REVISION VERSION 5.0 FOR 1ST SUBMITTAL

SHEET 1 OF 5
SEPTEMBER 25, 2025
JOB NO. 1183.60
STERLING RANCH EAST
FILING NO. 6

STERLING RANCH EAST FILING NO. 6

SHEET 3 OF 5
SEPTEMBER 25, 2025
JOB NO. 1183.60
STERLING RANCH EAST
FILING NO. 6

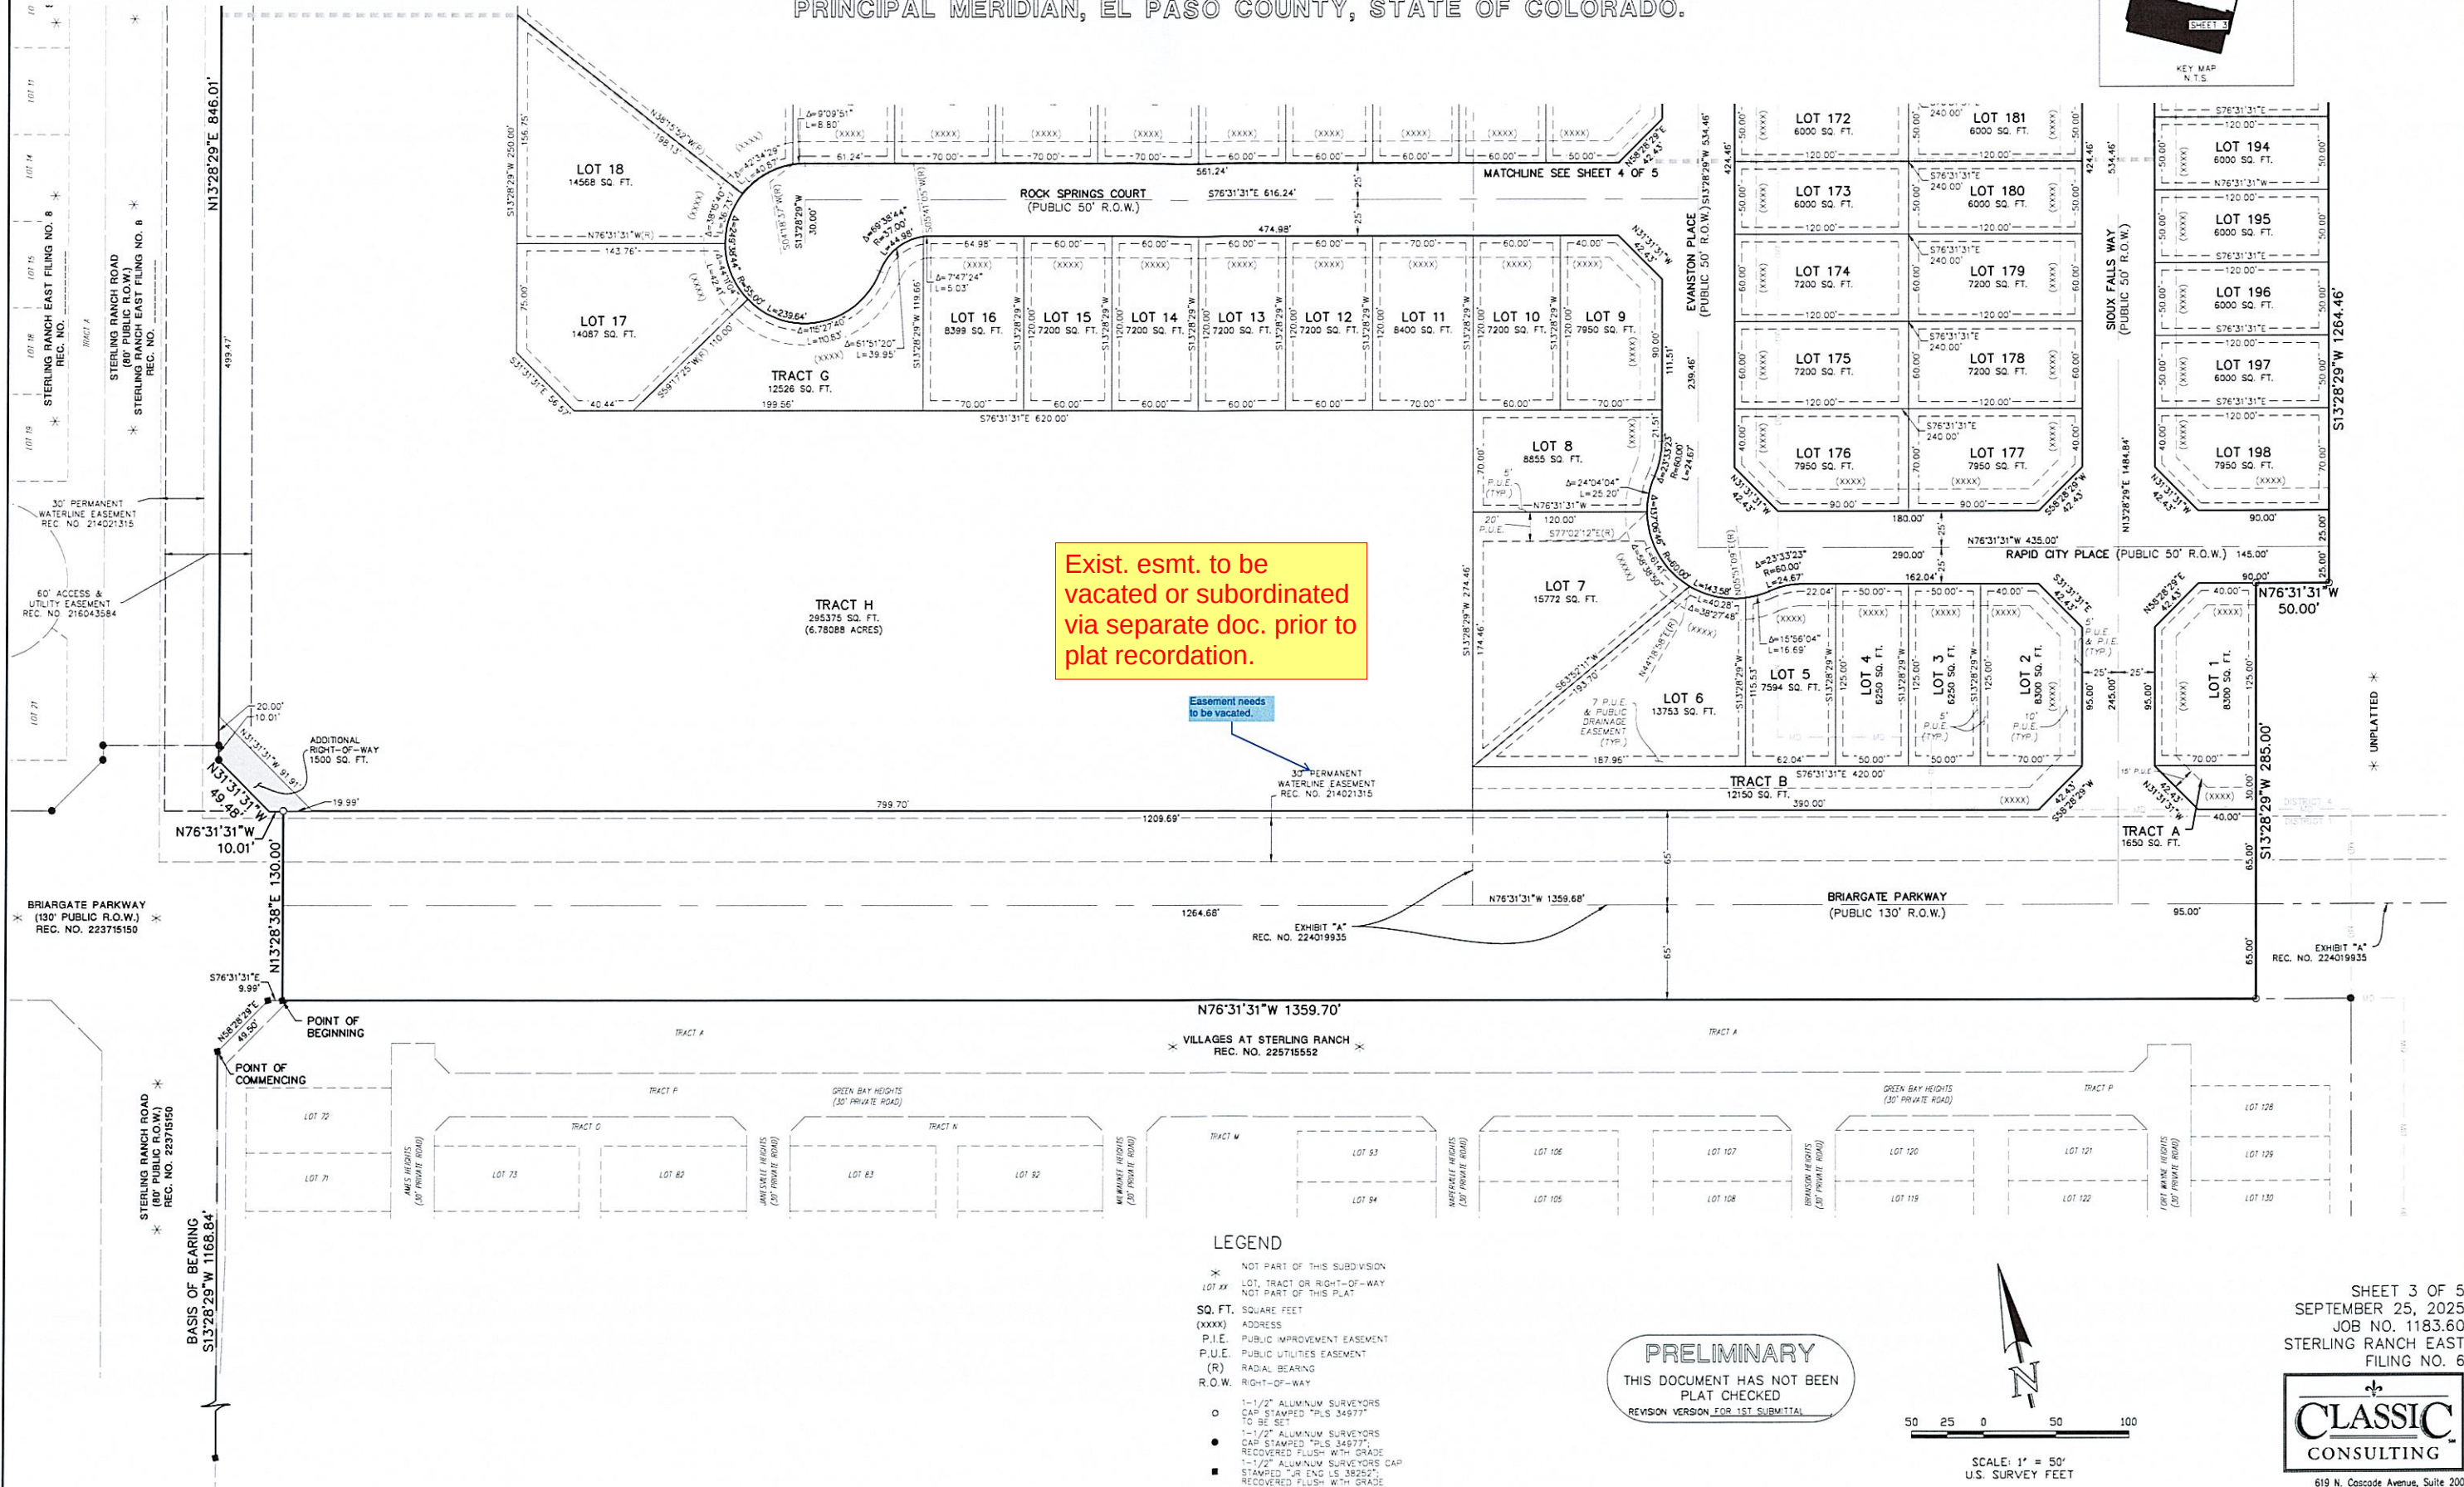
Exist. esmt. to be
vacated or subordinated
via separate doc. prior to
plat recordation.

Easement needs
to be vacated.

SHEET 4 OF 5
SEPTEMBER 25, 2025
JOB NO. 1183.60
STERLING RANCH EAST
FILING NO. 6

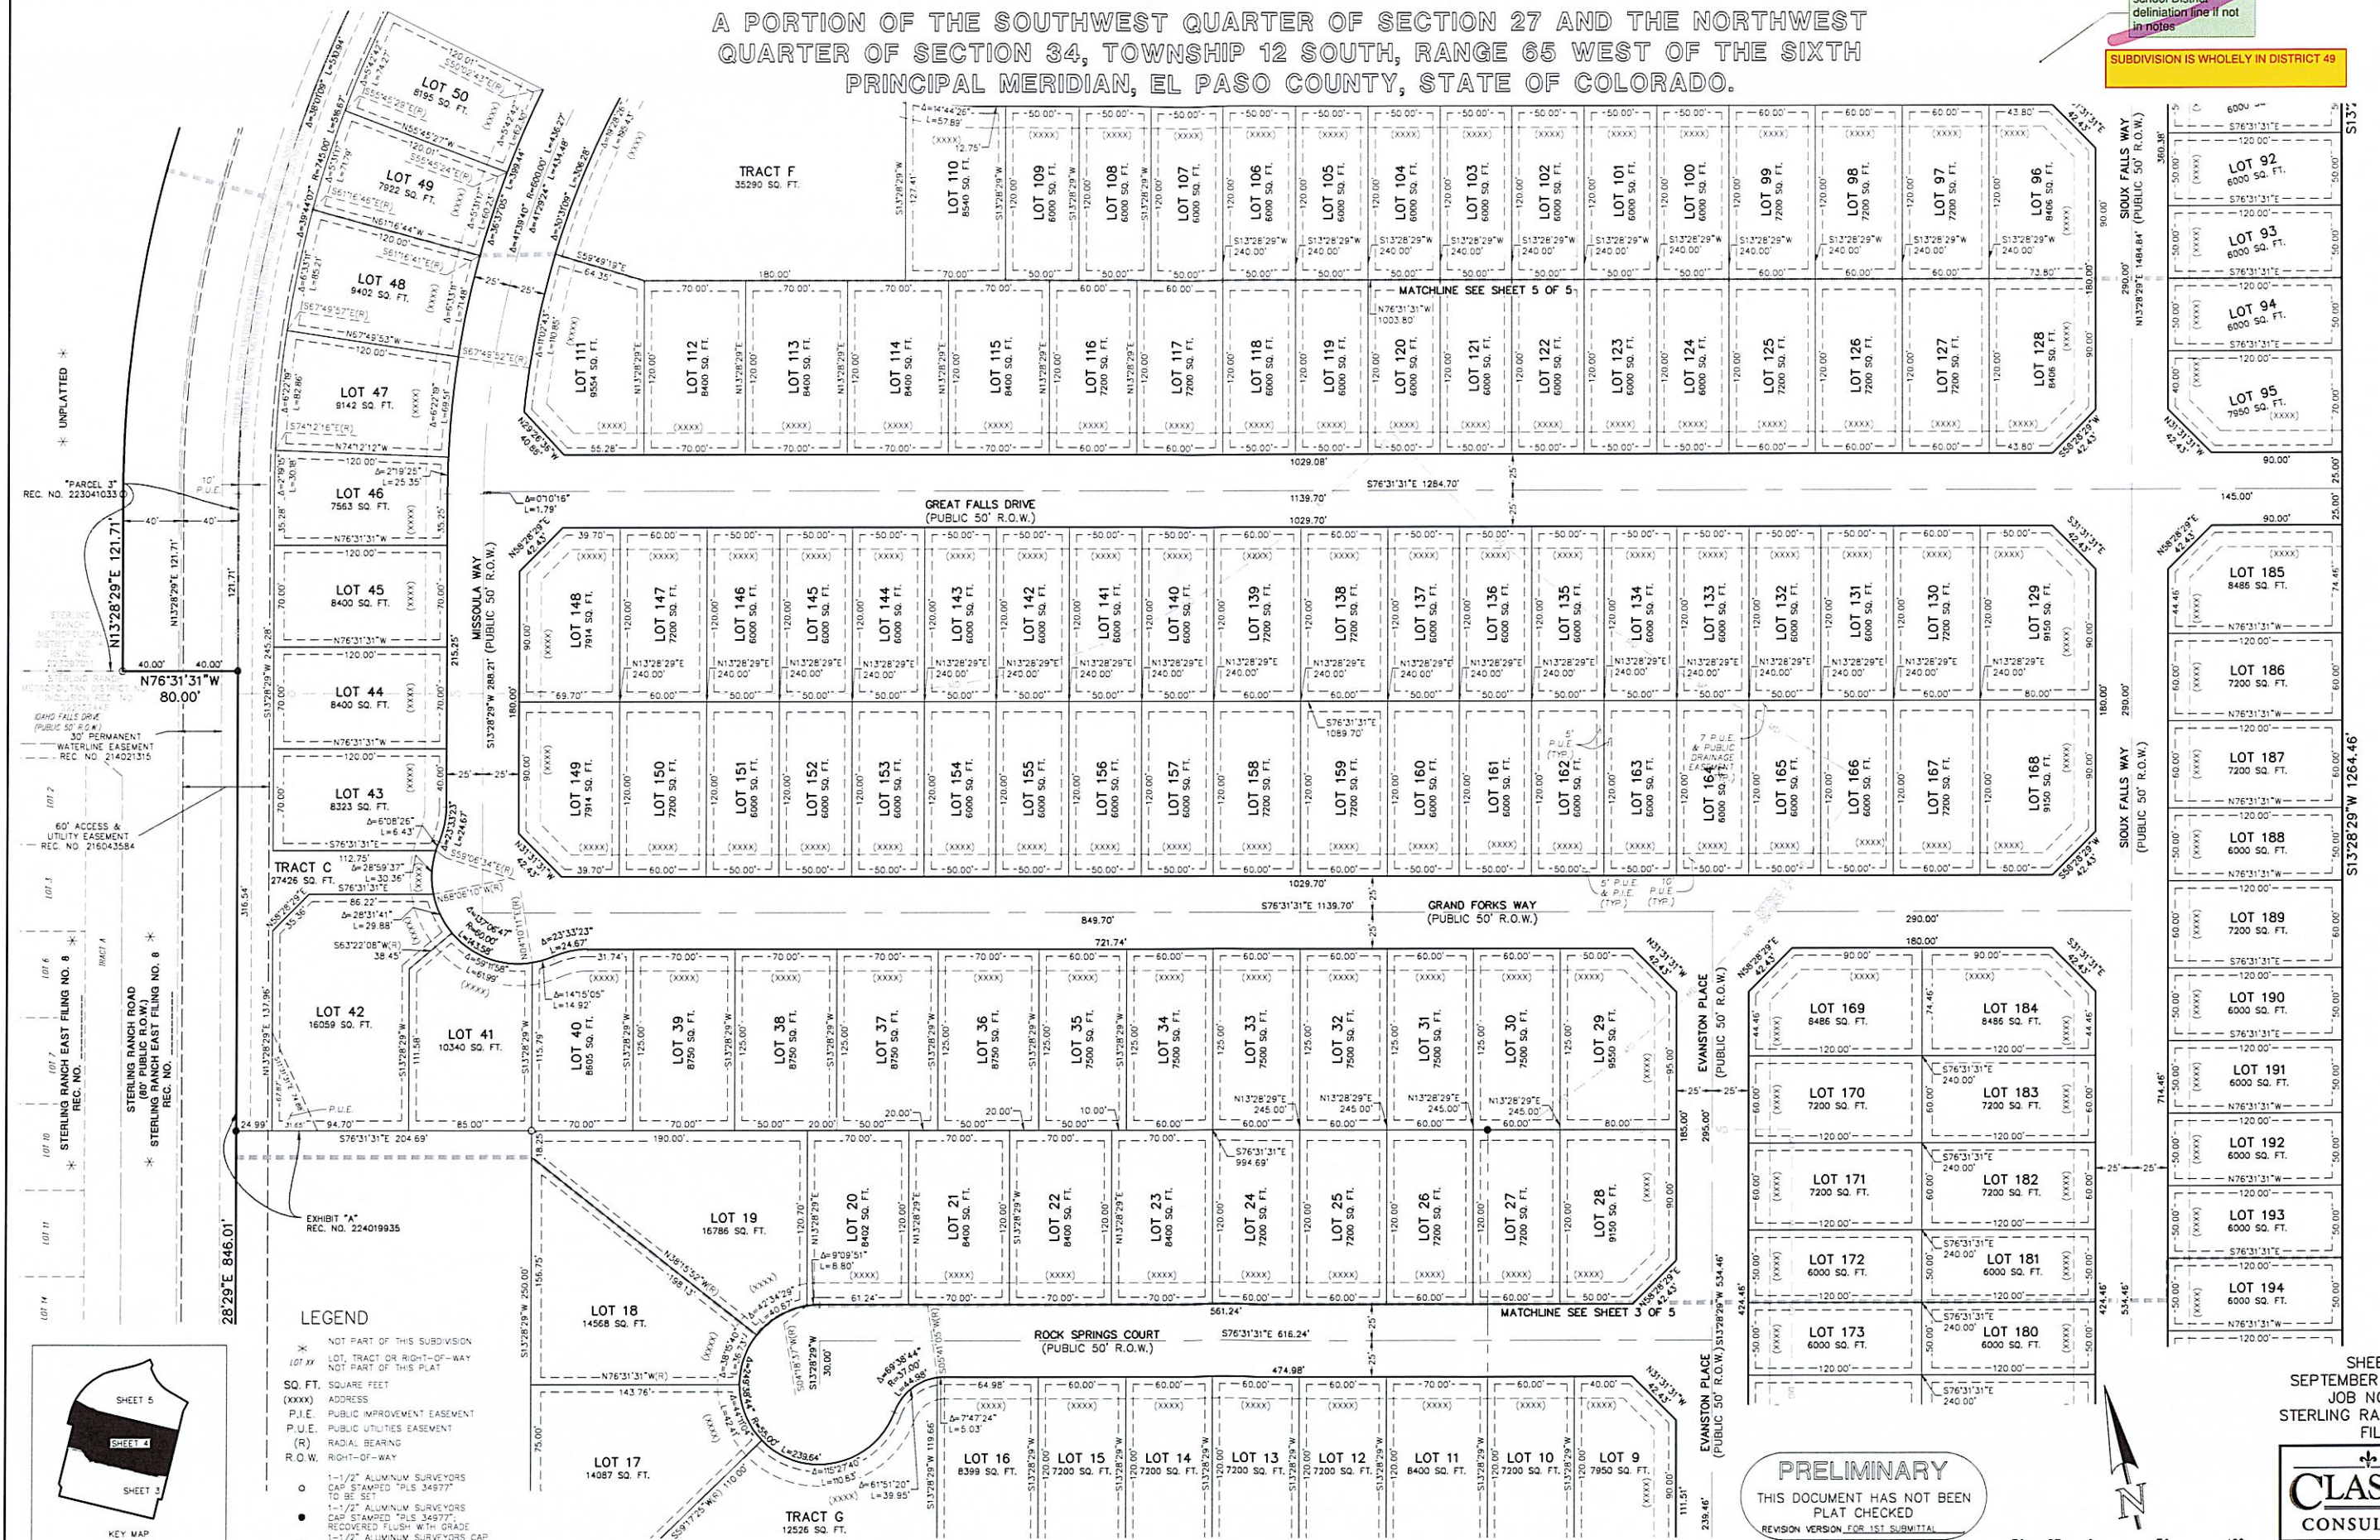
school District
delimitation line if not
in notes
SUBDIVISION IS WHOLLY IN DISTRICT 49
